ACCESSION NBR:8202090230 DOC.DATE: 82/02/05 NOTARIZED: NO DOCKET #
 FACIL:50-361 San Onofre Nuclear Station, Unit 2, Southern Californ 05000361
 50-362 San Onofre Nuclear Station, Unit 3, Southern Californ 05000362
 AUTH.NAME AUTHOR AFFILIATION
 DIETCH,R. Southern California Edison Co.
 RECIP.NAME RECIPIENT AFFILIATION
 EISENHUT,D.G. Division of Licensing

SUBJECT: Forwards ten potential findings repts processed & classified
 by GA Co.

Subject: Docket 50-361 and 50-362
San Onofre Nuclear Generating Station
Units 2 and 3

POTENTIAL FINDING REPORT
SONGS 223 SEISMIC DESIGN VERIFICATION

Figure 3.7A-95

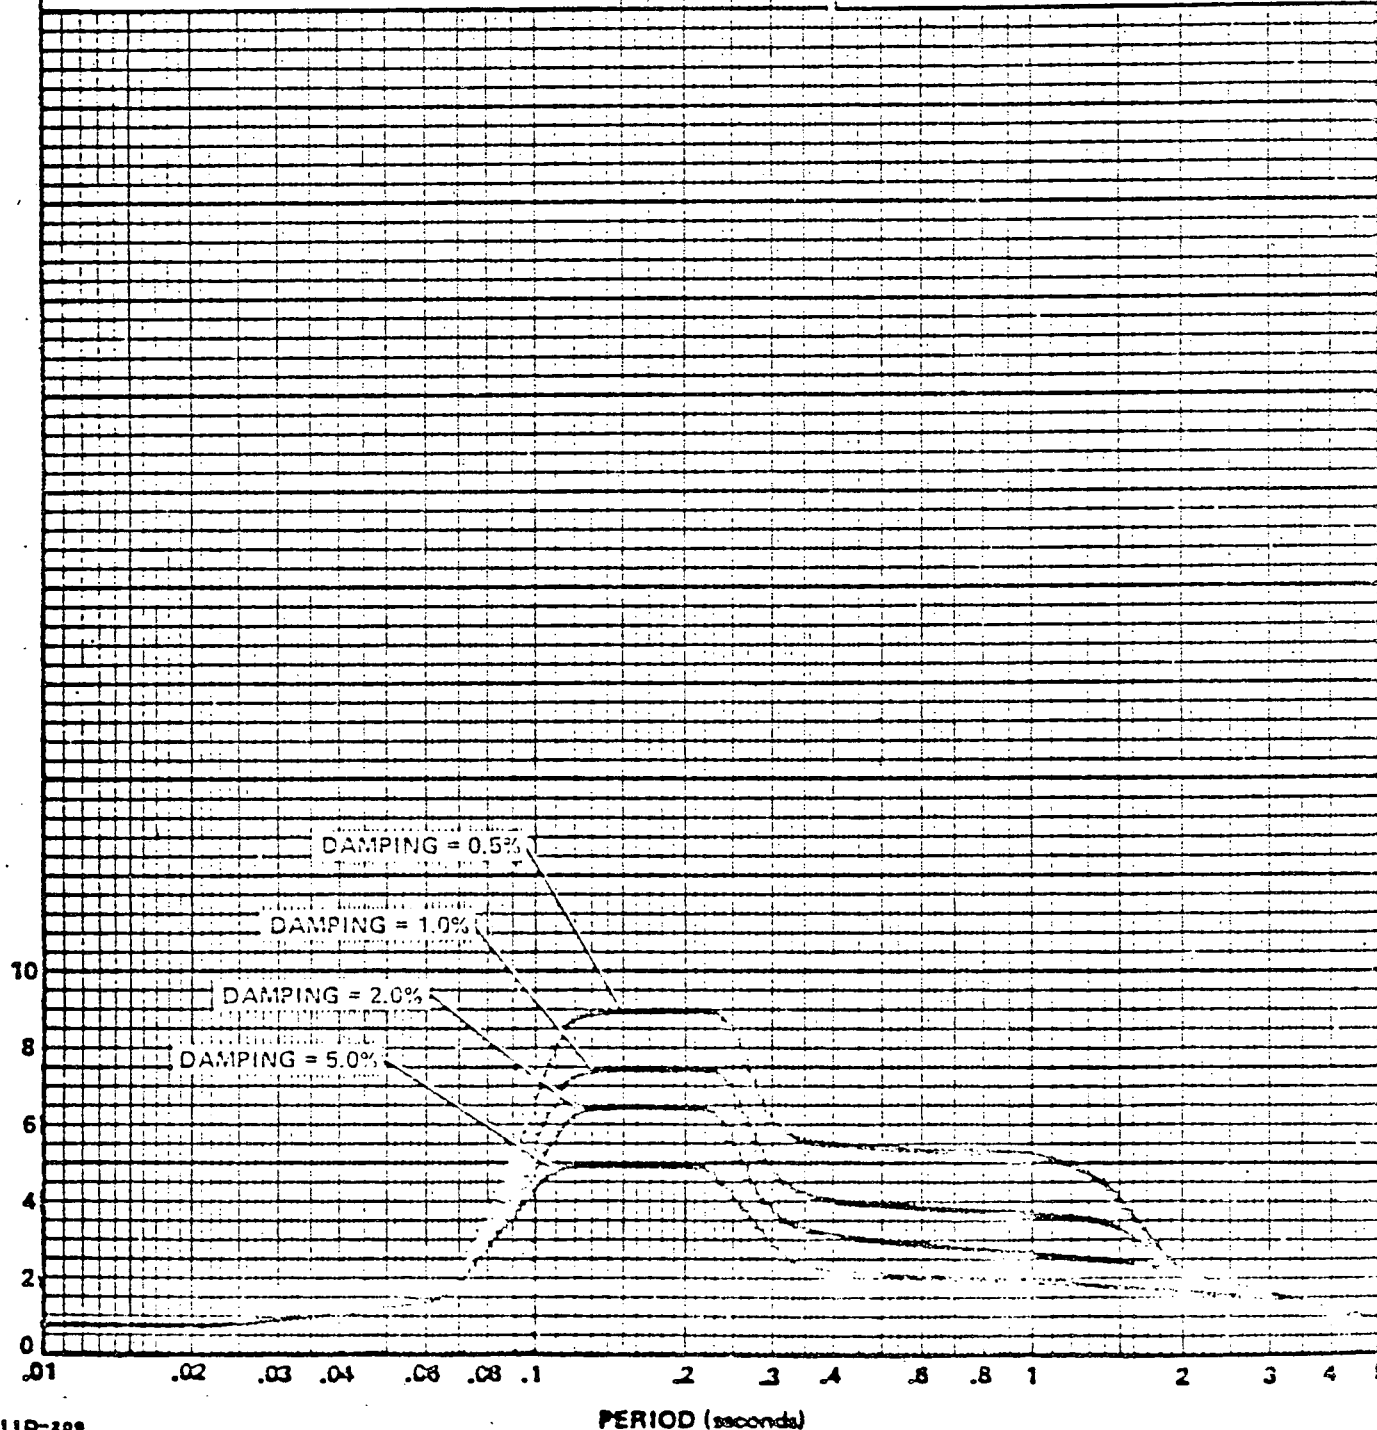
REQUIREMENT REFERENCE DOCUMENTS: San Onofre 2 & 3 FSAR, Fig. 3.7A-95, DBE Vertical Acceleration Response Spectra at Elev. -]5'-6" of Safety Equipment Building (Safety Injection Area).

BASIC REQUIREMENT: Building response spectra curves indicate vertical acceleration value of approximately 1.2g at 33 to 40 cps with 5% damping.

DESCRIPTION OF POTENTIAL FINDING: Vertical acceleration specified by C.E. and used in pump vendor (Ingersoll-Rand Co.) static analysis is 1.0g (Ref. C.E. Spec. 1370-PE-410, Rev. 07, and I-R Analysis Report EAS-TR-7625N), which is less than the FSAR criteria.

The FSAR reproduction of the seismic response curve is difficult to read in the area of concern. The BPC project curve, which is clearer, indicates better that 1.0g is the appropriate value. It is noted that a seismic response curve is a smooth envelope of calculated accelerations vs frequency values and is conservative for this reason.

Acceleration used in calcs too low but higher accel. does not cause allowable to be exceeded

For pump casing the stresses may be increased by 0.4%, which will reduce the existing design margin from 8% to 7.6%. (See calculation by L E Penzes, attachment #2)

SEISMIC ANCHOR MOVEMENTS

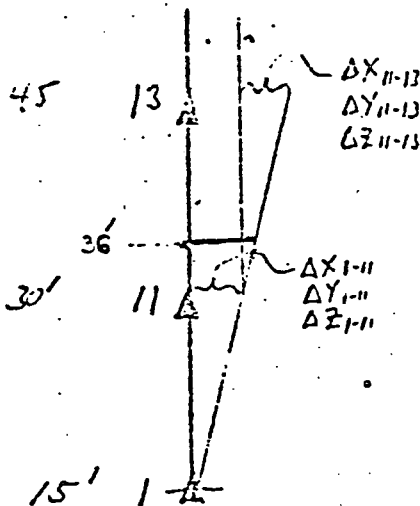
DESCRIPTION OF POTENTIAL FINDING: The criteria used for determining the seismic anchor movement (SAM) is not adequately documented and the calculation for the SAM at anchor 140 are not adequately explained.

The conservative assumption of SAM for nodes 5 and 30 is acceptable. However, the criteria used for determining the SAM SAM at Anchor 140 are

The SAM data for anchor 140 have not explained away.

The determination for the SAM at the anchor 140 is given on sheets 26, 27 and 28 of calc. M-1204-043-2 (PSC-78). The calculations and data used are adequately documented and traceable.
